Technical Bulletin 160

# **BTU-8000/8100 Analog Controller Module (ACM) Extended Warranty**

Version 1.0, Revision AA (20 March 2008)

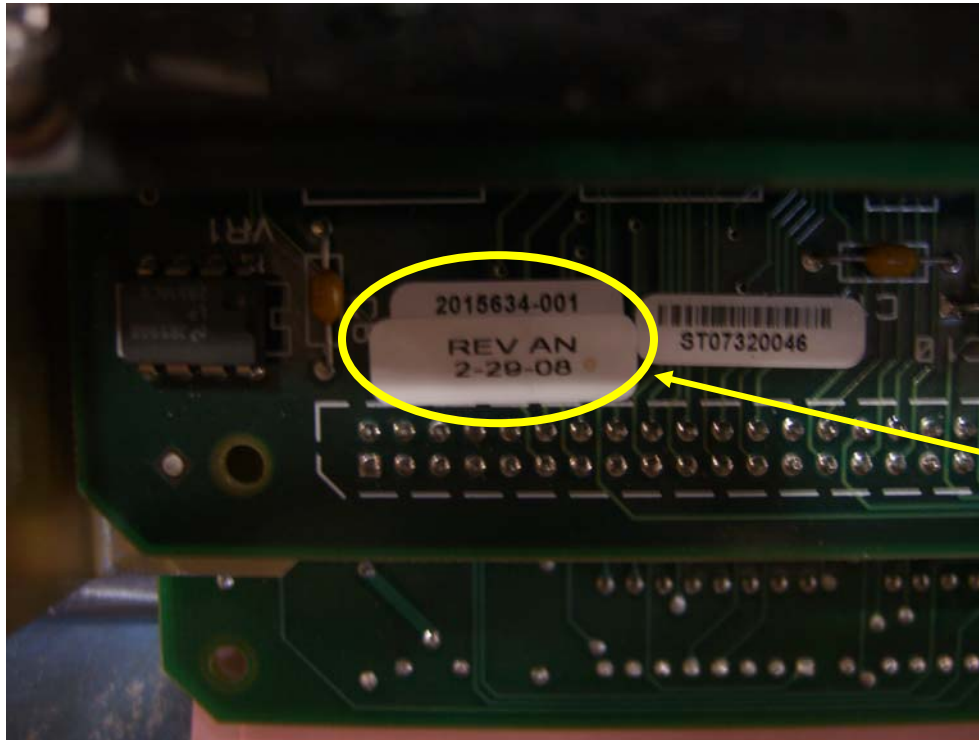
ACM part number 2105640-xxx is a combined digital electronics, analog electronics and barrier board. This part should be replaced as a combined unit. There should be a white sticker containing the part number and revision level on the assembly. The

bulletin describes a potential issue with all revision levels “AM” or earlier (see drawing below for revised revision level number). These fuse issues have been resolved with revision level “AN” or later.

Revision level “AN” or later includes all updates described in this bulletin
